1964 Corvette: Service Bulletin: 4-Speed Shift Lever Revision

Source: Chevrolet Technical Service Bulletin

Bulletin No: DR #691

Date: September 8, 1964

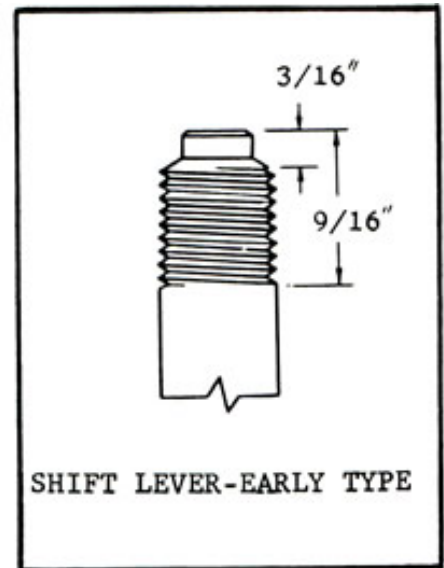
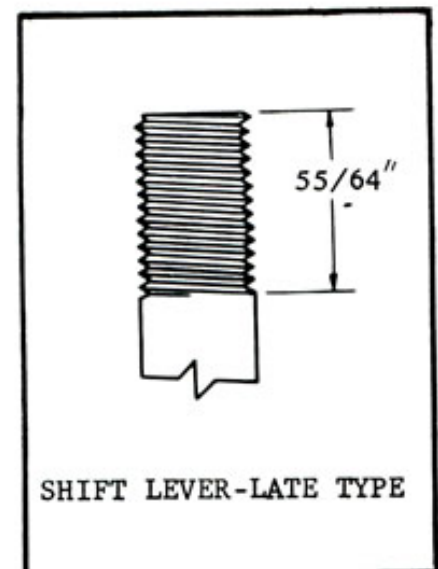
Two shifter knob designs and two shift lever thread designs have been used in 1964 production. The early design all plastic knob, part number 3846842, may be used on either lever. The late design knob, which has a threaded brass insert sleeve, can be used only on the late design lever. Refer to Figures 2 and 3 for details.

Regardless of lever or knob design, the threads must be free of burrs. The slot edges of the threads should be chamfered and smooth. When installing a knob, use extreme care to avoid cross-threading.

FIG. 4 - MODIFICATION OF SHIFT LEVER LOWER END

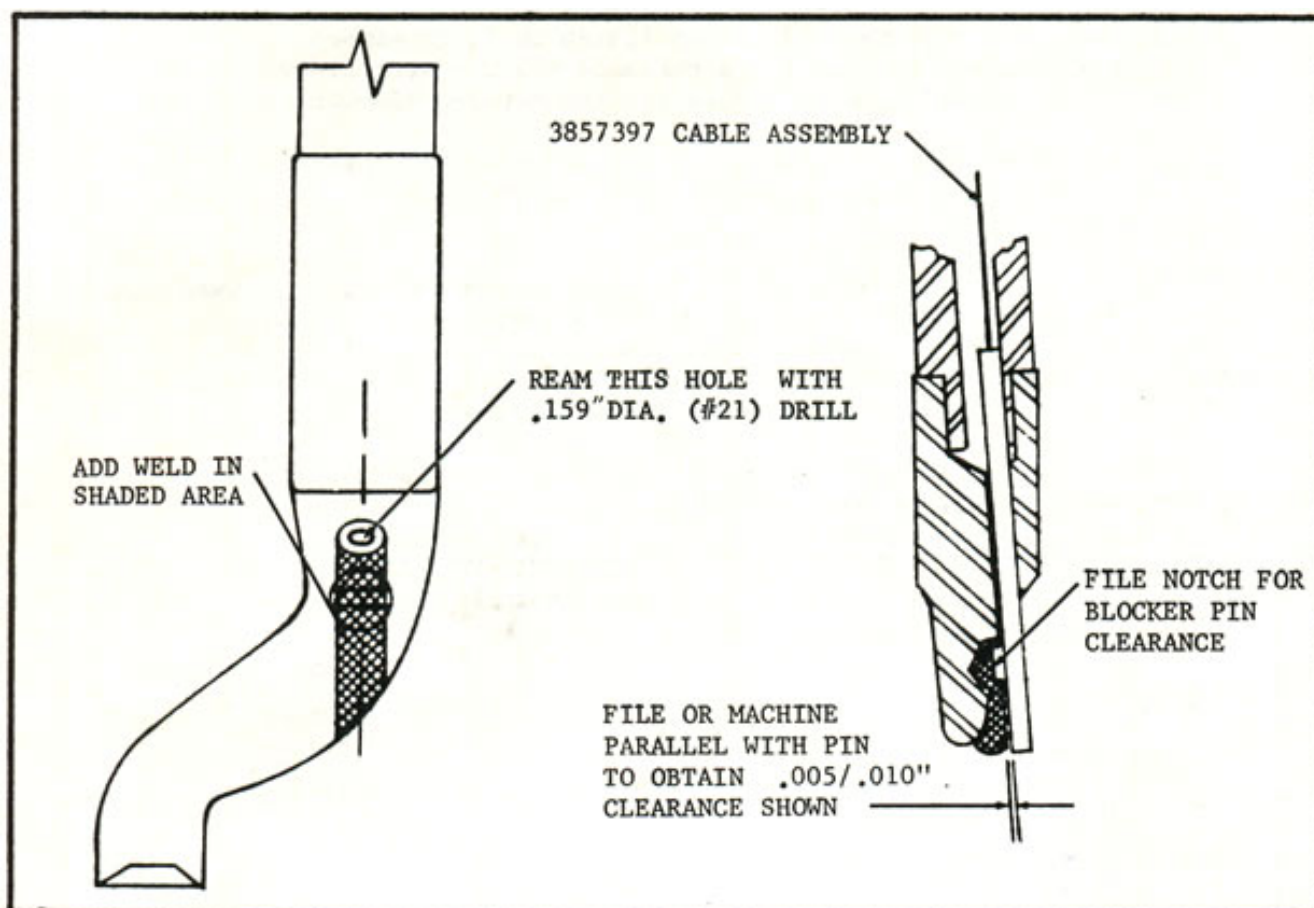
REVERSE INHIBITOR BINDS

2. Add a heavy weld or brass bead to the shift lever as shown by the shaded section of Figure 4.
3. File the bead flat and parallel to the reverse inhibitor pin with .005" to .010" clearance to the pin.
4. Remove and discard the pin and wire assembly from the "T" handle and enlarge the "T" handle hole to .082" with a 5/64" drill. Reassemble using the new pin and wire assembly, part number 3857397.

FIGURE 5 - REVERSE BLOCKER PIN LOCATING DETAILS

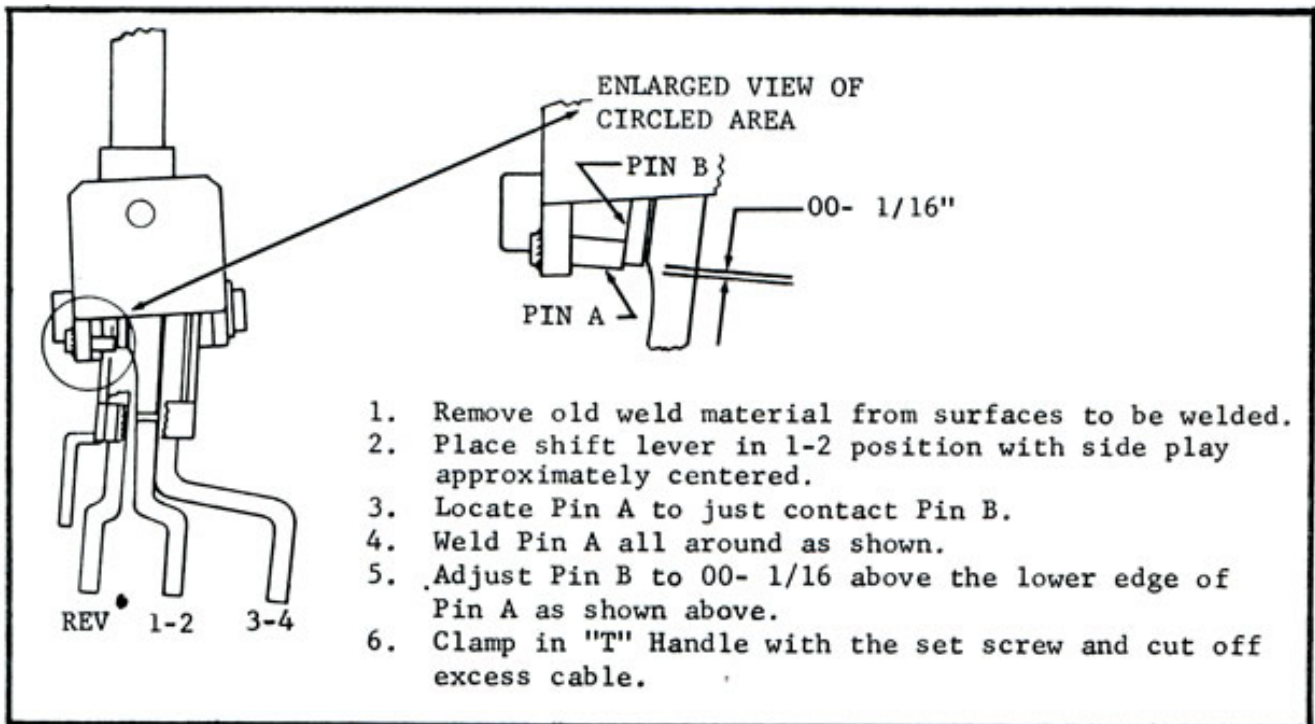
If the reverse blocker pin weld has broken, Figure 5 describes the proper locating dimensions for rewelding. If the original pin has been lost or damaged, a 1/4 inch by 5/8 inch hardened bolt, such as part no. 9409073, may

be used. The shift mechanism must be fully assembled before welding the pin so that the proper pin location may be achieved.
